Shop Drawing Submittal Review

Project Name: Webster University-**ISB**

Copies	No.	Description
1 PDF	221119P02	(Submittal No.'s)
		(Cannon #22 1119-004) – (Paric #15051-) – (WES #607)
		• **Domestic Water Piping Specialties**

PROJECT NAME: Webster University ISB
LOCATION: St. Louis Missouri
CLIENT PROJ. NO.: N/A
WES PROJ. NO.: 607
SPEC SECTION: 22 1119 Domestic Water Piping Specialties
SUBMITTAL ITEM: See Below -

660-G2B 652-A

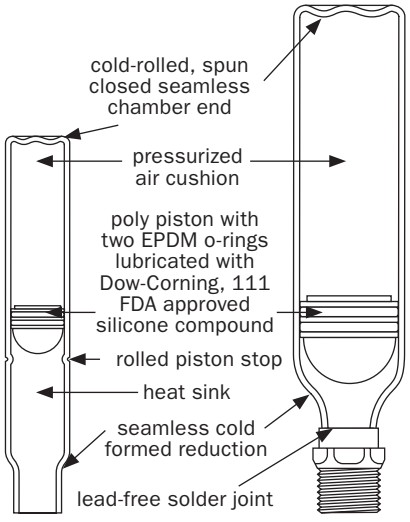
1. Provide type/style specified. Refer to specification section 221119, Part 2 Products, paragraph 2.12.
2. Refer to Plumbing Fixture Schedule on drawing P0601.
